MUTHANNA VILLAGE ROADS  
SEGMENT 4  
GOVERNORATE OF  
MUTHANNA, IRAQ

**PROJECT NUMBER SIGIR-PA-06-055**

SUBJECT: Report on Project Assessment of the Multhanna Village Roads Segment 4,  
Muthanna Governorate, Iraq (Report Number SIGIR-PA-06-055)

## Muthanna Village Roads – Segment 4 Governorate of Muthanna, Iraq

Diagram 3. Typical cut cross section

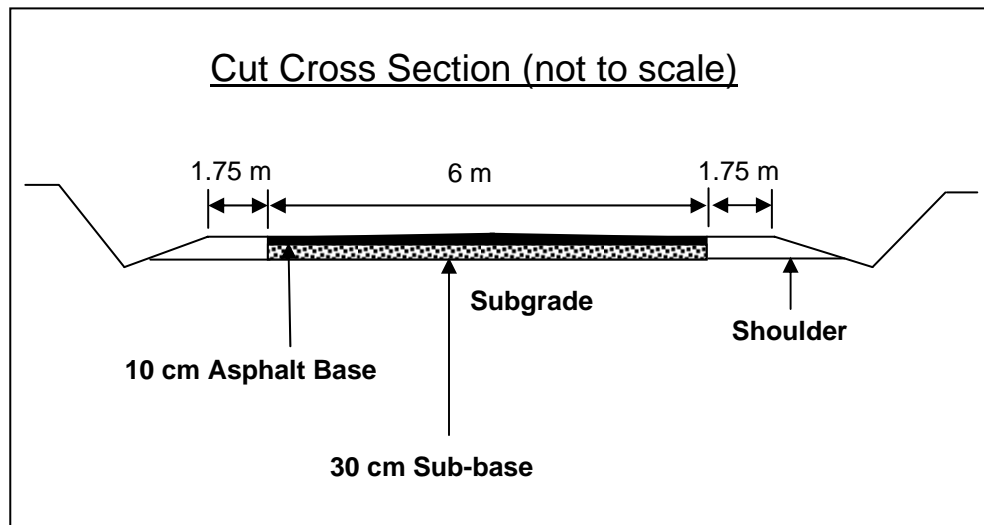
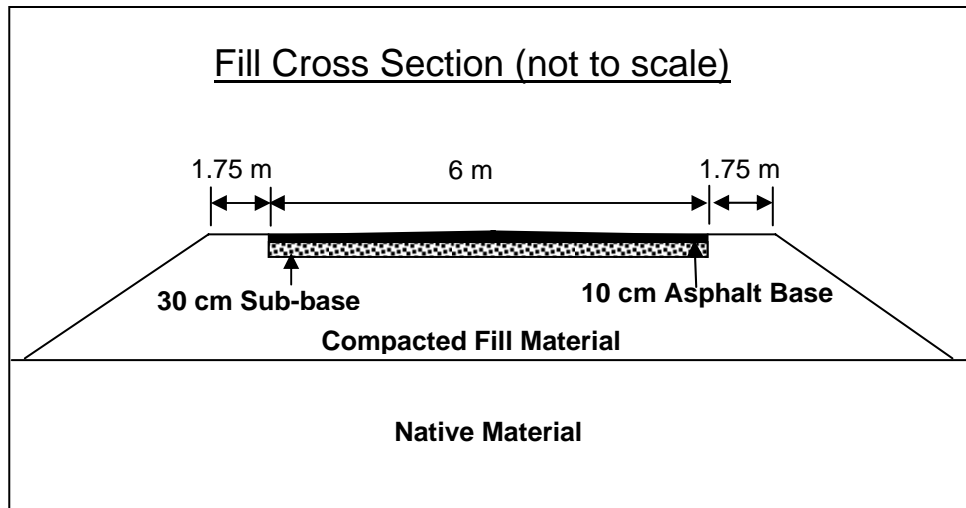
Diagram 3 illustrates the typical cut section provided in the contract drawings. On a cut section, unneeded materials are removed so as to match the elevations provided in the design profile. The excess materials removed can then be used to widen the embankment (if needed) or to build fill sections of the roadway.

The contract BOQ and typical cross section drawings required the contractor to spread the sub-base layer, using Type B material with a thickness of 30 cm and a width of approximately 6.5 m in accordance with Section R6 of the Iraq Standard Specifications for Roads and Bridges, and direction from the USACE RE. According to the Iraq Standard Specifications for Roads and Bridges, Type B sub-base material is a sand-gravel mixture containing coarse and fine aggregate. The specifications required the coarse aggregate to consist of hard, durable particles or fragments of gravel free from dirt and other objectionable matter. In addition, the specifications required the fine aggregate to be natural sand, free from organic and other objectionable matter.

The BOQ and typical cross section drawings required the contractor to spread the base layer of asphalt concrete with a thickness of 10 cm and width of 6 m. The contract required the asphalt concrete paving to be in accordance with Section R9 and R8A of the Standard Specifications for Roads and Bridges, and directions from the USACE RE. Based on the status report provided by the USACE RE, the contractor had paved approximately 4 km in Section 1 (stations 0+000 to 4+000) and about 8 km in Section 2 (between stations 9+500 and 17+000).

The QAR’s deficiency log indicated the contractor took corrective action to fix the prime coat problems. According to the USACE RE, the pavement edge problems will not be corrected until the 1.75 m wide shoulders are in place alongside the paved base layer. Once the shoulder work is complete the deficient pavement areas will be repaired to their required widths. In the case of the problems shown in Site Photo 9, the USACE RE reported the road will be repaired when the additional borrow is available to widen the roadway fill structure (Diagram 3) in order to obtain the required section widths for the sub-base, pavement, and shoulders.
